Dear Editor, Dear Reviewers,

We would like to thank you for your consideration of our manuscript and the careful review and feedback you provided us with. Please find below a detailed point-by-point answer to the reviewers' comments.

Anonymous Referee #1

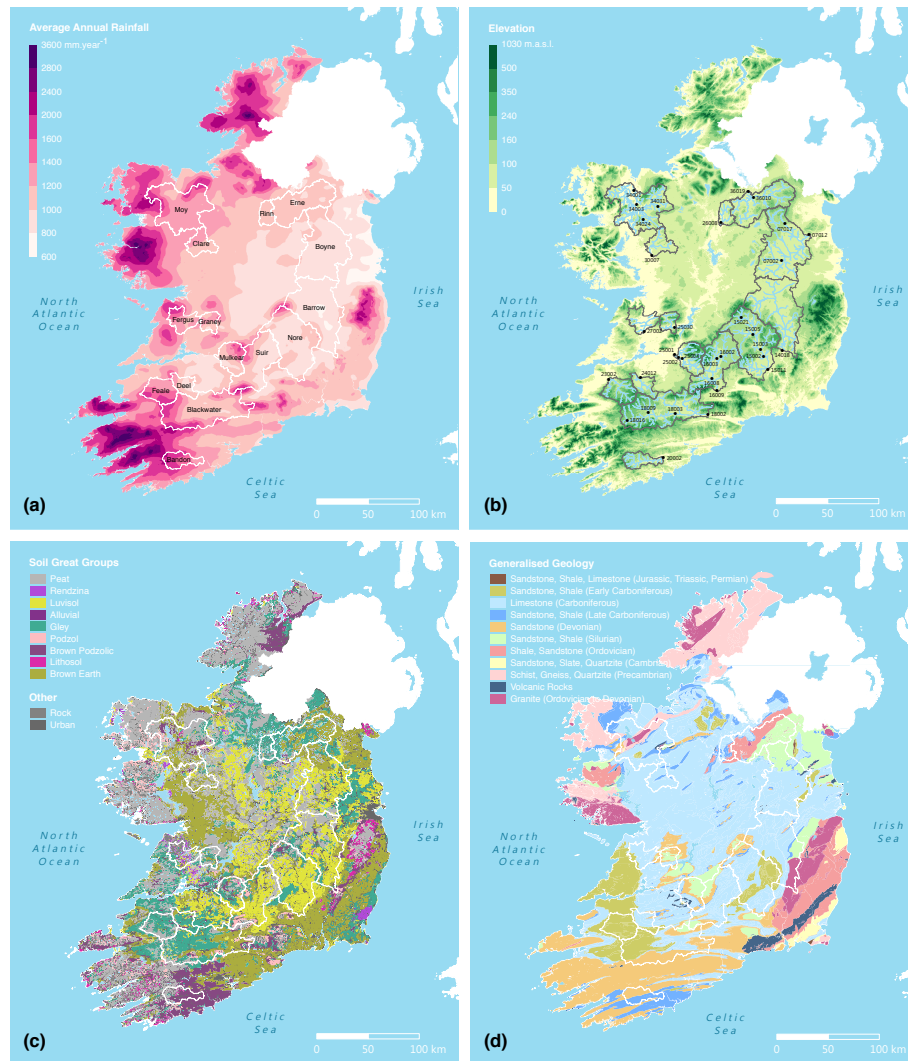
R1C9: P4 L24-30: Can you say how many catchments are nested? How does that affect the generalization of the results? You mention that the catchments represent the diversity in soil types and geology - therefore, I would provide more explicit information about soil type and geology. Is there any snowfall in the study catchments?

AR: There are 15 distinct catchments, and as a consequence 18 nested catchments. This information is added in section 2.2: *“A total of 33 gauges (displayed on Figure 1b) featured sufficient data of good quality to be used as study catchments, amongst which 18 are nested within any of the 15 distinct catchments.”* (P5 L21-23) and complemented this by displaying both the 15 distinct catchments on new Figure 1a, and the 33 gauges on new Figure 1b.

Figure 5. Comparison of the overall performance in evaluation of the model calibrated with the six objective functions. The three traditional objective functions used as evaluation efficiencies. E_{KG}^Q corresponds to the original Kling-Gupta efficiency (Gupta et al., 2009).

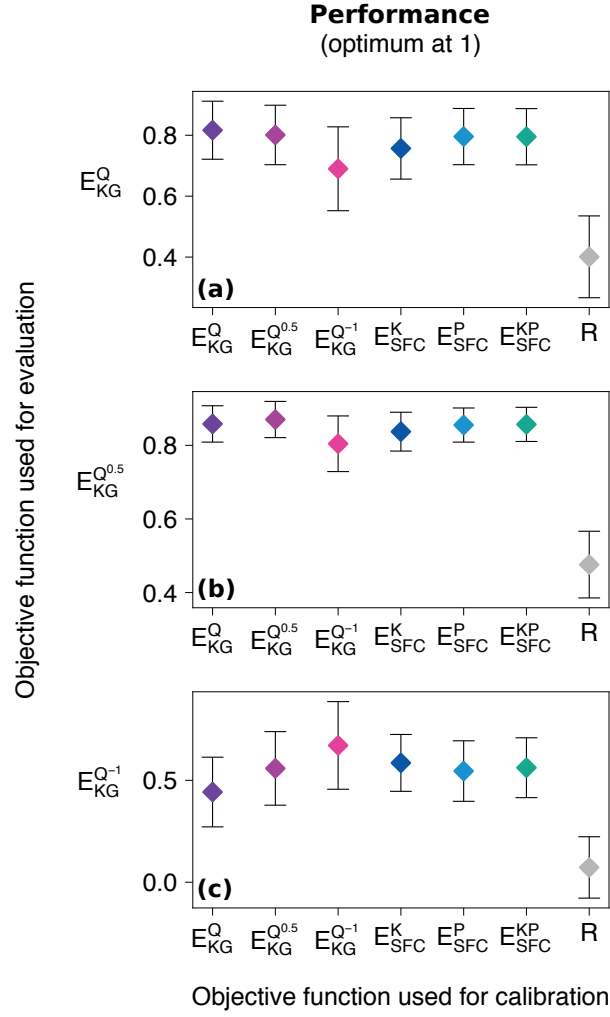
R2C29: In Figure 6 caption, specify that E_{hi} is Kling-Gupta efficiency

AR: We agree that E_{hi} was not very explicit for a reader glancing at the Figure. Because, we decided to rename all objective functions to E_{KG} , including the traditional objective functions so that their name is more explicit: E_{hi} becomes E_{KG}^Q , E_{av} becomes $E_{KG}^{Q^{0.5}}$, and E_{lo} becomes $E_{KG}^{Q^{-1}}$. And we have added the explanation for E_{KG}^Q in the caption of new Figure 5 (replacing old Figure 6)

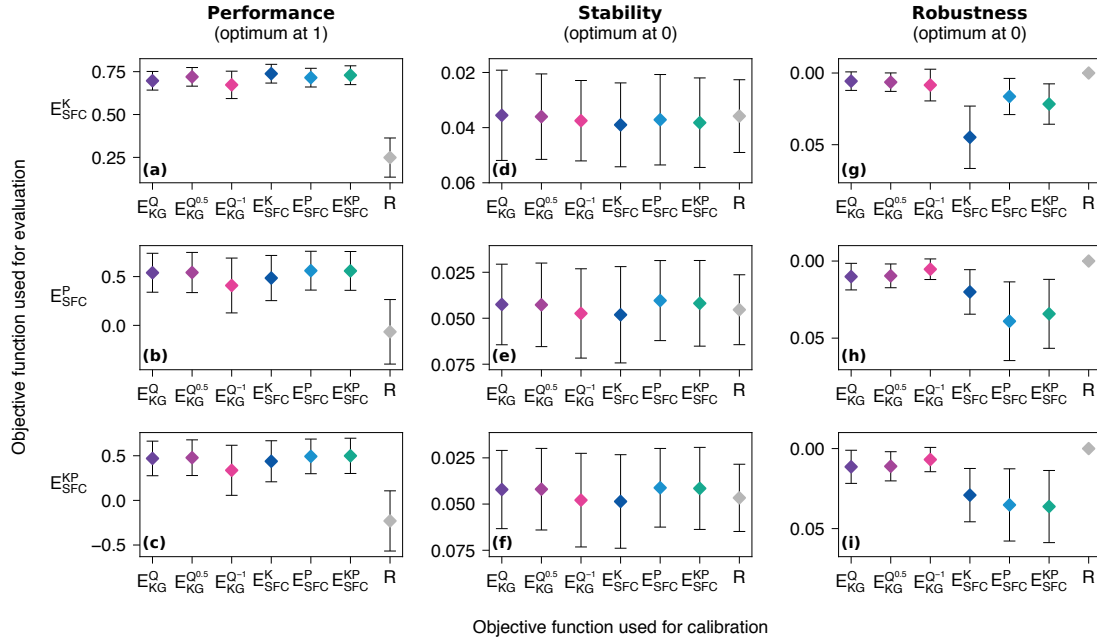
R2C6: There are some problems of disagreement between results text and results figures. For example, the results text in section 4.2 does not match the results shown in Fig. 7 (see specific comments below). Please ensure correct labeling of figure panels and revise text or figure as needed to ensure agreement. There is also disagreement between results text in section 4.4. and results shown in Fig. 9 (see specific comments below).

R2C32: P9 L16-17: Again, I don't see this in fig. 7. The two largest combinations of SFCs are Dfsh in (a) and Dall in (c). As stated, Ehi performs best for Dall in (c), but for Dfsh in (a), it appears that Eav performs better than Ehi. For the smallest combination of SFCs, Dinv, fig. 7 shows that Ehi performs best but the text states that Eav performs best. Please check that all panels of fig. 7 are labelled correctly and revise the text (or figure if needed) so that the figure and text are in agreement.

AR: Indeed, the labels were swapped by mistake. This is fixed in new Figure 6 (that replaces the old Figure 7).

AR: There was a mistake in the labelling of Figure 7. This has been corrected in the new Figure 6 (replacing the old Figure 7). Apologies for the confusion.

AR: As per comment **R2C6** and **R1C24**, there was a mistake in the labelling due to a late reordering of the objective functions from the one with the smallest number of SFCs, to the one with the largest number, that was not replicated in the label ordering. This is now fixed in the new Figure 6 (replacing old Figure 7).

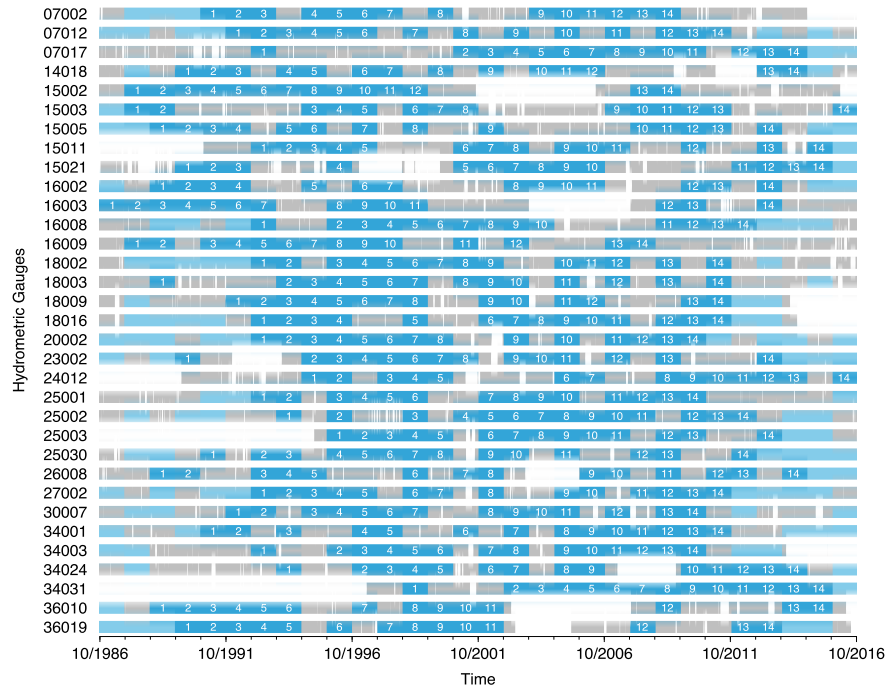
R1C20: Fig. 2: I agree that the information in Fig. 2 is interesting for someone working with the same data set. But its information is maybe not so relevant for the general reader. You could think about placing the figure in the supplemental material.

AR: We believe that the information contained in this figure is useful (especially in combination with new Figure 3 on the split-sample tests to be able to infer the exact years used in each catchment). However, in order to take into account the reviewer’s suggestion, we have moved the figure to the appendix rather than the supplement (new Figure A1).
